SPERRY MARINE UK

Service Bulletin No.12 (Release 3)

Product: BridgeMaster E Series Radars

Subject: Fitting of Flash (Software) PCBs V3.xx series

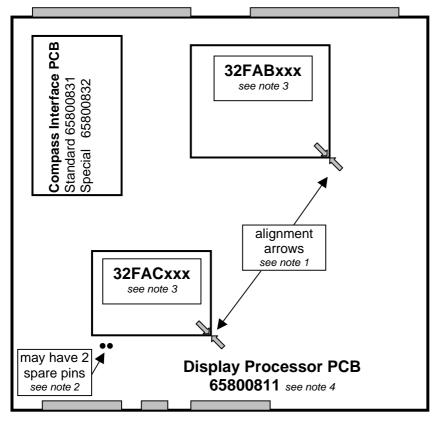
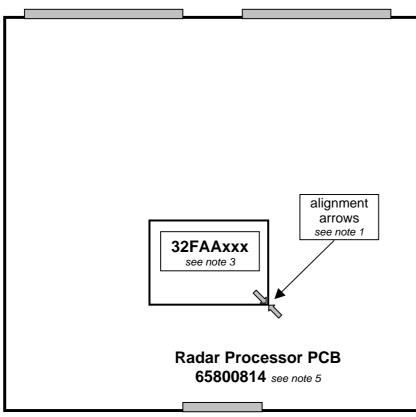
- Ensure the alignment arrows face each other when fitting the PCBs.
- 2. On Display PCBs issue 3 and above there will be 2 pins unsued.
- 3. xxx indicates Software Version:

ALL 3 FLASH PCBs MUST BE THE SAME VERSION NUMBER

- Display Processor MUST be issue 3 or>
- Radar ProcessorMUST be issue 4 or >
